TECH ADVISORY for  
Fuel Funny Cars previously built to SFI Spec 10.1E  
Revised: January 9, 2008  
Page 1

Soon a new SFI Specification for Fuel Funny Cars will be issued for newly built cars. In the meantime, for existing cars previously built to SFI Spec 10.1E, they must be retrofitted either with the current McKinney fix or with the following updates. These requirements are for Fuel Funny Car only and EXISTING CARS ONLY.

Steering Cross Member Tubes (#7)  
(attachment method not shown)

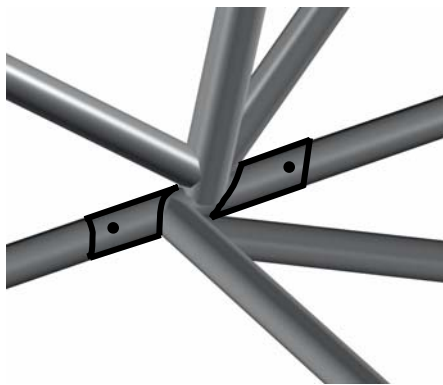
1. Two Steering Cross Member Tubes (#7) of 1 1/8" x .058" tubing, suitable for mounting the steering gear box, must be mounted with four attachment points, bolted or with slip tubes, using minimum 3/8" diameter bolts. Mounting points shall be a minimum of 6 inches apart, centerline to centerline, and in the same plane. An "X" design is also acceptable for the Steering Cross Member Tubes (#7). Steering Cross Member Tubes must be connected with two 1" x .058" tubes located approximately a third of the way from the end of the steering cross members span as illustrated below.
